# Technical Guidance

## Raft foundations - edge detail

SECTION THROUGH EDGE OF FLOOR SLAB AND EXTERNAL WALL

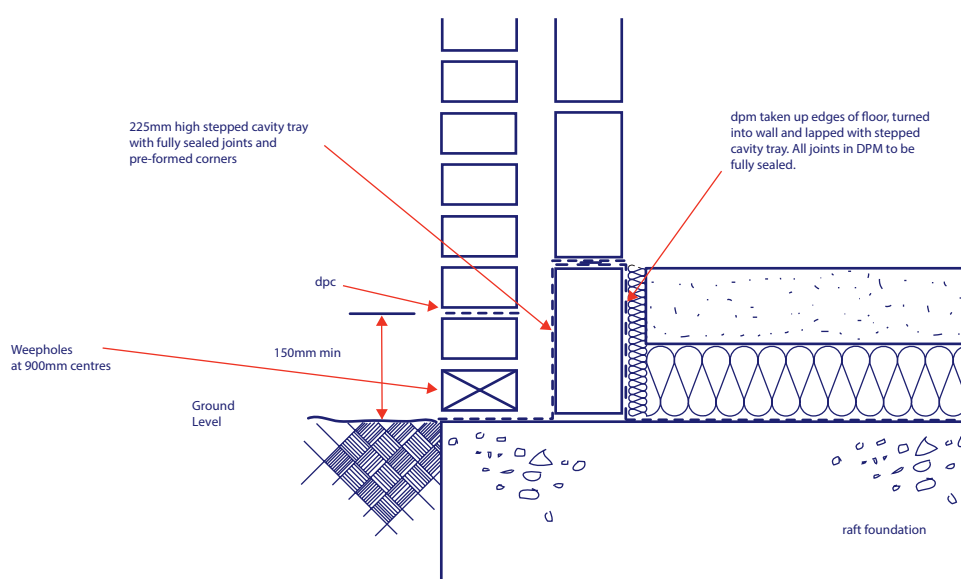
Does a raft foundation slab require a 'toe' for support of the outer leaf of a cavity wall and to provide weather-proofing at the floor/wall junction (as shown in NHBC Standards clause 4.5 – D12)?

Raft foundations can be accepted without a toe provided it can be shown that there is adequate weather-proofing at the junction of the wall and the raft.

The detail shown below is one acceptable method of achieving this. It uses a combination of a stepped cavity tray and dpm together with pre-formed corner trays and sealed lap joints.
